**RE: Lopez West
Bridge Blvd. Sw
Grading and Drainage Plan Stamp Date: 9/25/12
Pad Certification Date: 4/11/22
Hydrology File: L11D067**

DRAINAGE AND TRANSPORTATION INFORMATION SHEET (REV 6/2018)

Tel: (505) 281-2444		Cell: (505) 264-6042	
DATE	REVISION	LOT 316A, UNIT 3, TOWN OF ATRISCO GRANT ALBUQUERQUE, BERNALILLO COUNTY, NEW MEXICO BRIDGE BLVD / EUACARIZ LOPEZ WEST Grading & Drainage Plan	
9.21.12	ADDR. COA		
	9.19.12 LET		
1/16/20	AS-BUILT 1-3		
4/7/22	AS-BUILT 4-6		
DESIGNED BY: PWC	DRAWN BY: CCE	JOB #: LOPEZ_F	1 OF 1
CHECKED BY: PWC	DATE 7/2012	FILE #: G/D

GRADING & DRAINAGE PLAN

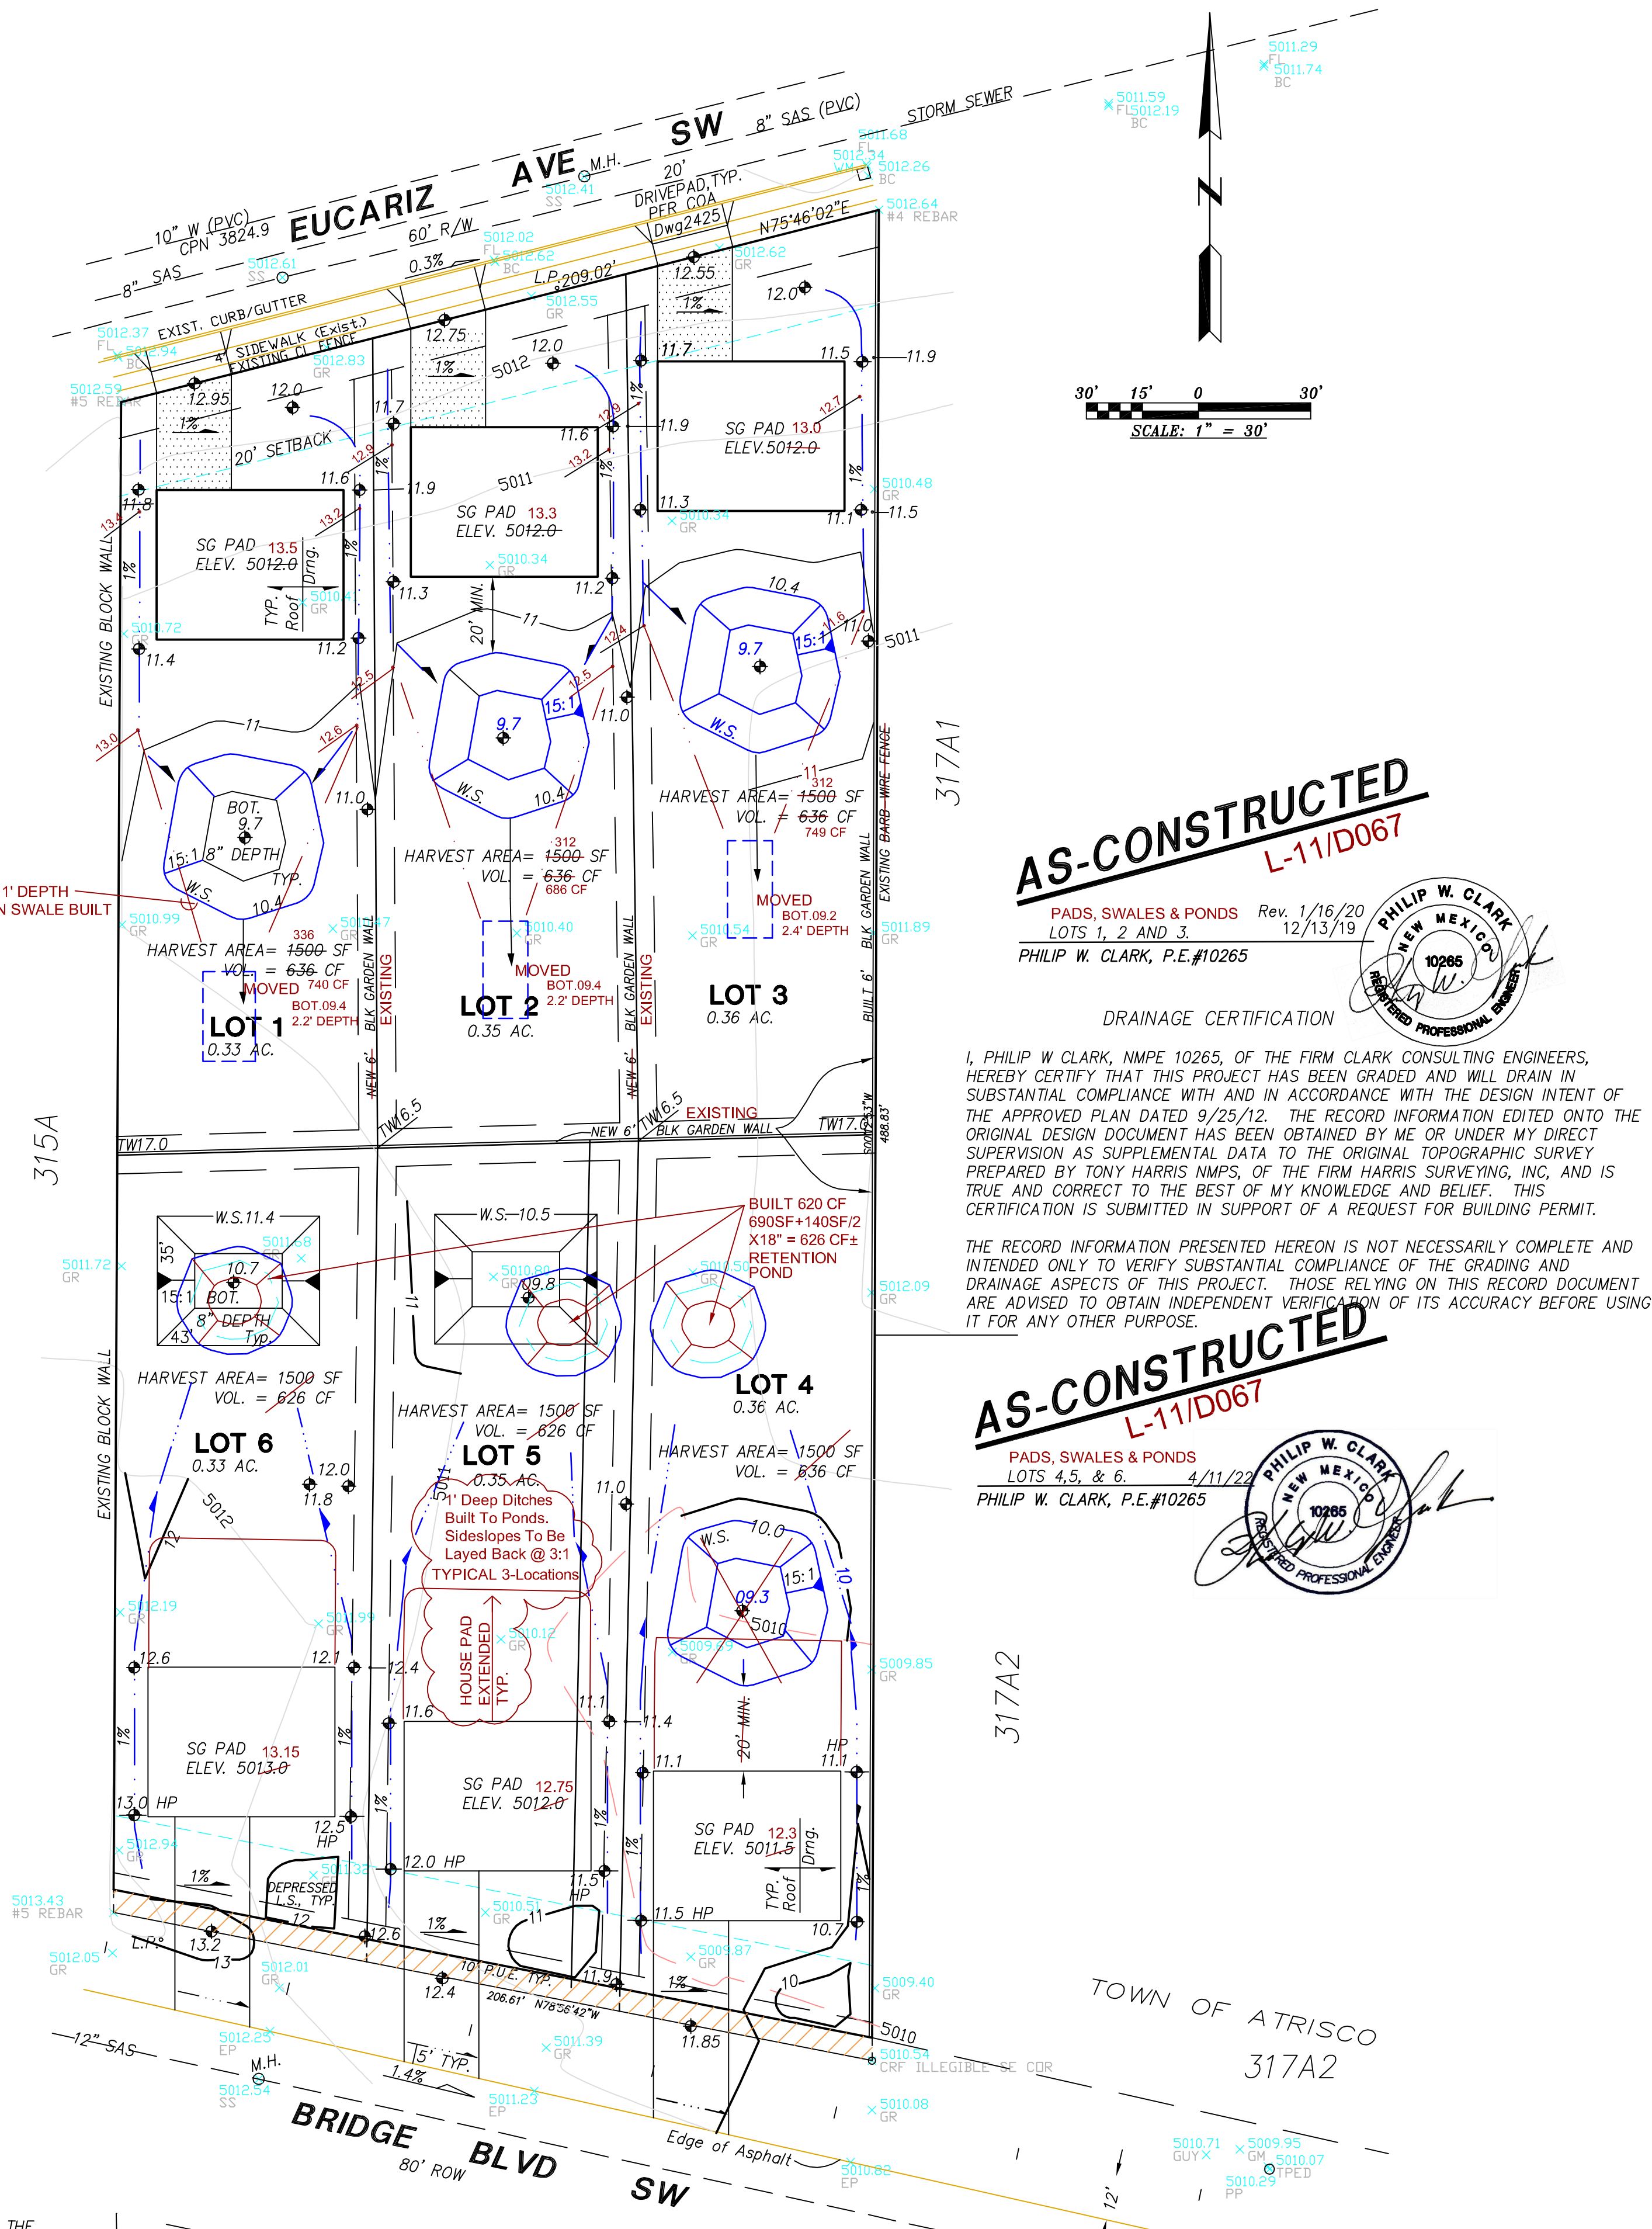
Based on the submittal received on 4/13/22, and site visit 4/15/22 the Pad Certification is approved for Building Permit by Hydrology.

As a reminder, if the project total area of disturbance (including the staging area and any work within the adjacent Right-of-Way) is 1 acre or more, then an Erosion and Sediment Control (ESC) Plan and Owner's certified Notice of Intent (NOI) is required to be submitted to the Stormwater Quality Engineer (Doug Hughes, PE, jhughes@cabq.gov, 924-3420) 14 days prior to any earth disturbance.
